**Date:** May 22, 2019  
**To:** Planning Board  
**From:** Lincoln Daley, Community Development Director  
**Subject:** Family Dental Care of Milford for the property located at Tax Map 19, Lot 13, 150 Elm Street and Tax Map 19, Lot 14, 154 Elm Street. Public hearing for a Major Site Plan application to construct a 5,400 square foot addition to the existing 2,400 square foot dental office and related parking, landscaping, lighting, and drainage improvements within in the Commercial District and Nashua-Elm Street Overlay District.

**BACKGROUND/PROPOSAL:**

SHEET TITLE:  
**SITE PLAN**

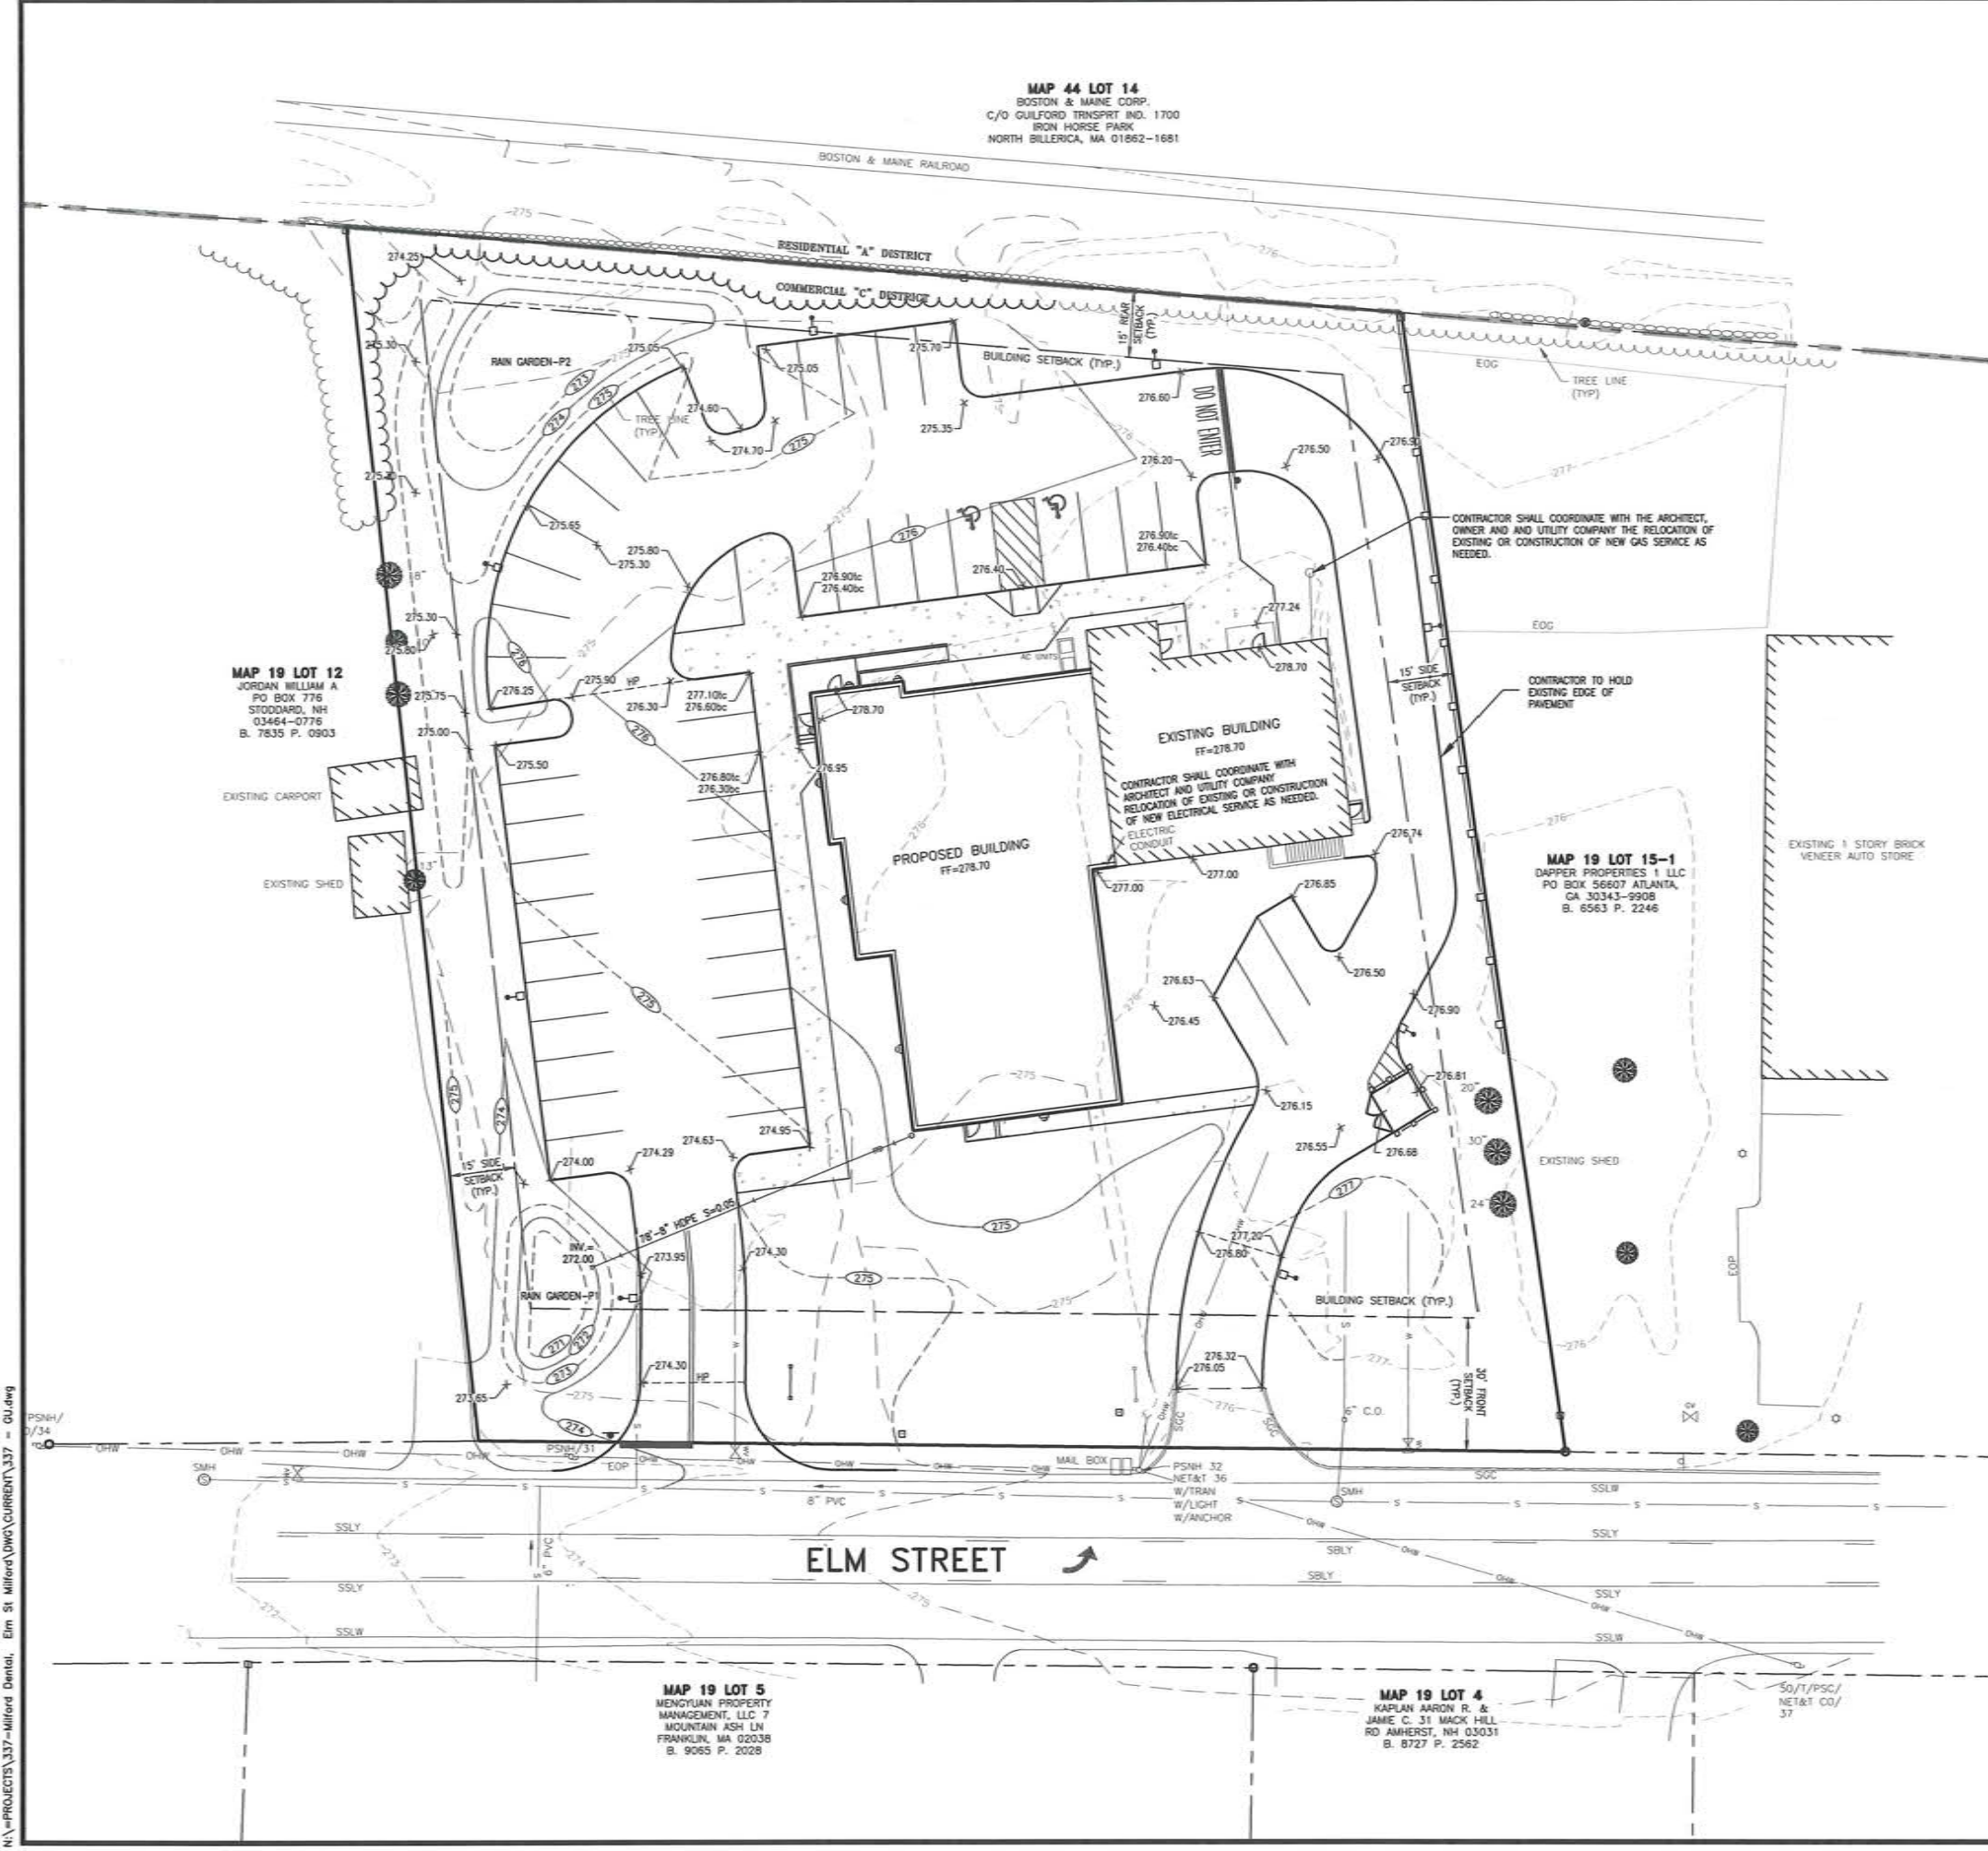
6. Sheet 4. Signage. The plans states that the existing free standing sign will be relocated. The plans further state that the proposed sign plan to be completed by another party. Please revise the plans to include any/all monument, directory, wall, and direction signage and their associated design, construction, and engineering details.

7. Sheet 4, Dumpster Screening. Please revise the plans by include the design and construction details for fencing and gate around the perimeter of the dumpster and pad.

8. Sheet 4. The Zoning Ordinance, Section 6.05.6.B.1.a states that all projects subject shall construct wherever feasible interconnecting driveways to adjacent properties or provide secure future connections through easements to adjacent property boundaries. Please explain why the project does not contain interconnecting driveways to abutting parcels.

9. Sheet 4. The Zoning Ordinance, Section 6.05.6.B.1.c, requires that interior parking lots shall provide for shared use and interconnected drives. Please revise the plans or submit a waiver request.

10. Sheet 4. The Zoning Ordinance, Section 6.05.6.B.1.b. requires that new access points onto Nashua or Elm streets shall only be created when it is not feasible to combine or share existing access points. Please explain why the project contains two access points. What alternatives were considered for eliminating one of the access points?

11. Sheet 4. The Zoning Ordinance, Section 6.05.6.C.3 Build-to-Zone states that new structures shall be constructed so as to maintain a traditional streetscape edge. Further, the setbacks of adjacent structures and context of spacing between buildings shall be considered in determining the appropriate building setback. At a minimum, a new

12. Sheet 4. The Zoning Ordinance, Section 6.05.6.D.2.b Building Orientation states that buildings shall be sited so that entrances are clearly identifiable and directly accessible from a sidewalk and shall be accessible for pedestrians, bicyclists and future public transit users. The applicant submitted a waiver request for relief from this requirement to locate/orient the entrance to the rear of the building. See waiver request.
